UNITED STATES  
NUCLEAR REGULATORY COMMISSION  
WASHINGTON, D. C. 20555

SAFETY EVALUATION BY THE OFFICE OF NUCLEAR REGULATION

REACTOR INTERNALS BOLTING PROBLEMS

RANCHO SECO NUCLEAR GENERATING STATION

## LOCATION OF FRACTURE

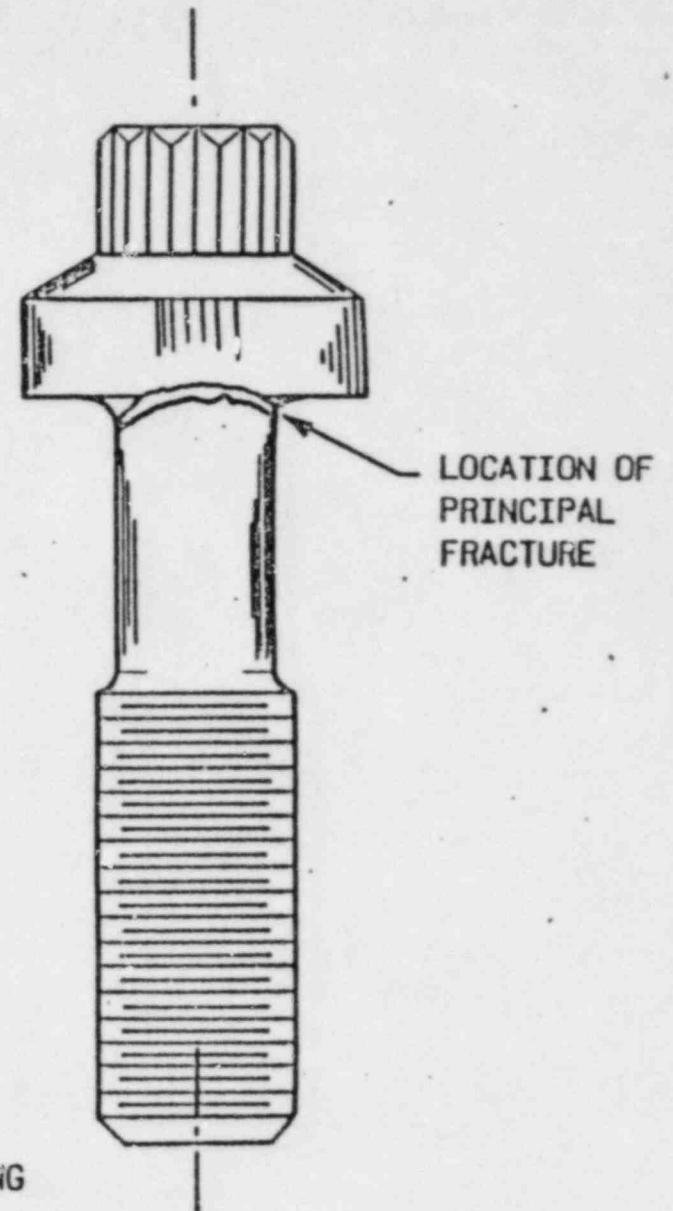
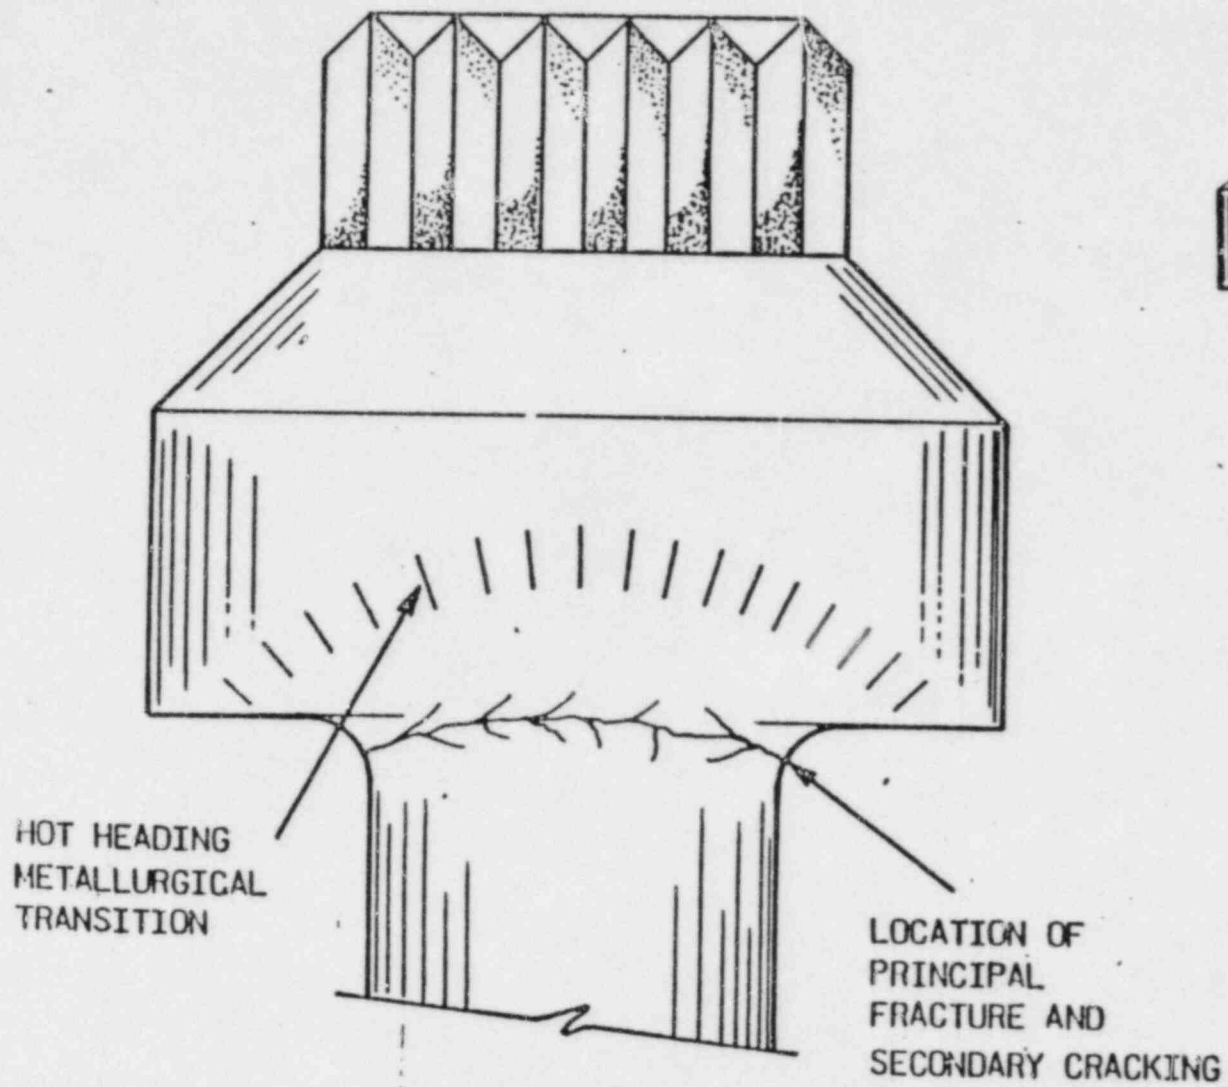
Of these bolts, only the UCB and LCB bolts have core support significance. Cracked bolts have been randomly distributed around the joint without specific pattern with the location of cracks at the head-to-shank transition region of the bolt (see Enclosure 1). This area is a region of high stress concentration due to geometric discontinuity.
